From: Kevin Rice <kprice@up.com>
Sent: Friday, July 8, 2022 9:09 AM
To: Buckley, Maggie
Cc: Assenza, Adam; Phoebus, Elizabeth (Betsi); Tabachnick, Alan; Bushey, Sabra; Luhnnow, Glenna
Subject: [EXTERNAL] RE: PIRATE 60% Design Questions/Comments
Attachments: UPRR Mesa Gateway PIRATE STB Coordination 2022-07-07.xlsx

From: Buckley, Maggie <Maggie.Buckley@jacobs.com>
Sent: Thursday, June 23, 2022 4:38 PM
To: Kevin Rice <kprice@up.com>
Cc: Assenza, Adam <adam.assenza@stb.gov>; Phoebus, Elizabeth (Betsi) <Betsi.Phoebus@jacobs.com>; Tabachnick, Alan <alan.tabachnick@stb.gov>; Bushey, Sabra <Sabra.Bushey@jacobs.com>; Luhnnow, Glennda <Glennda.Luhnnow@jacobs.com>
Subject: PIRATE 60% Design Questions/Comments

Our team has reviewed your 60% plan set and has a few questions and comments to inform the EA, as shown in the table below. The yellow highlighted items are the highest priority. We noticed at least one area where your proposed ROW has been widened beyond what is shown in the 30% plans – we need to confirm this ASAP because if it is accurate, it may require additional field work and documentation that could affect the overall EA schedule.

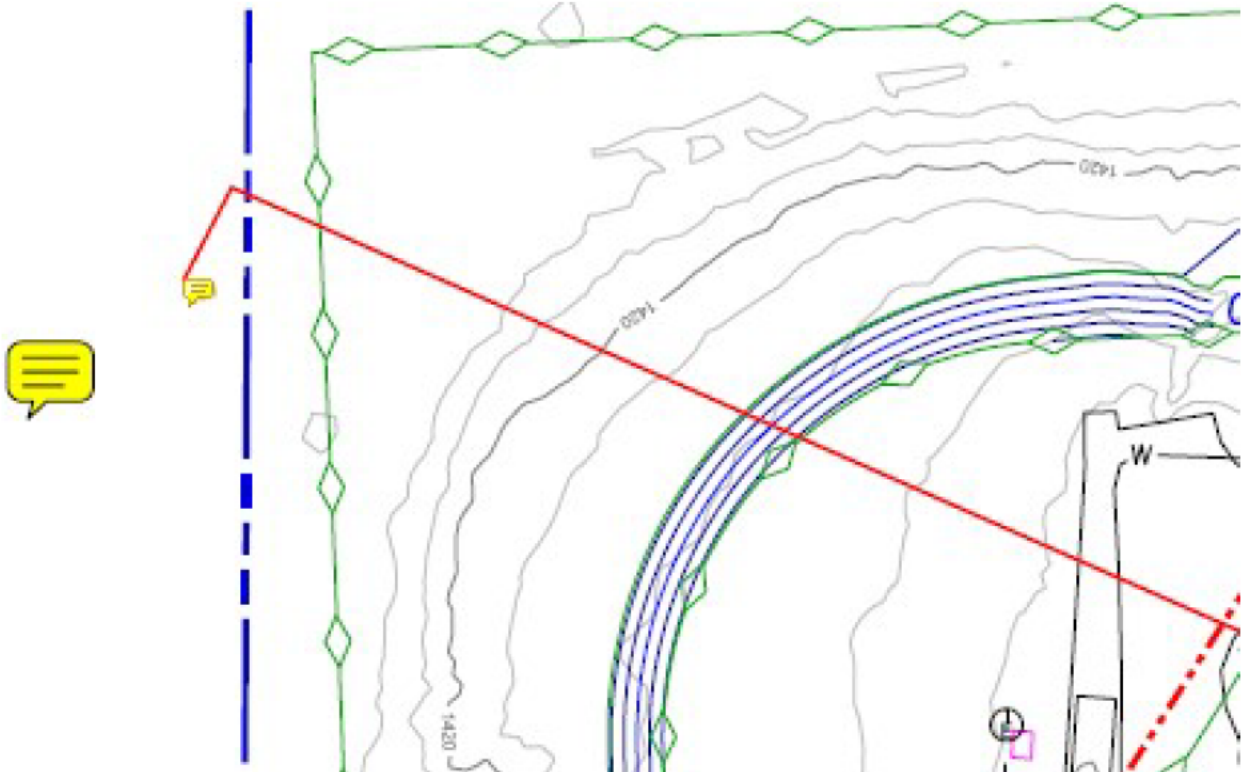
GD003 (128)	Can a cross-section be provided in this area (see red line below in snip)? It would be helpful to understand how deep the cut would be and what the surface elevation of this area would be following grading. Would it have a single ditch a couple of feet deep or would the entire area be graded?
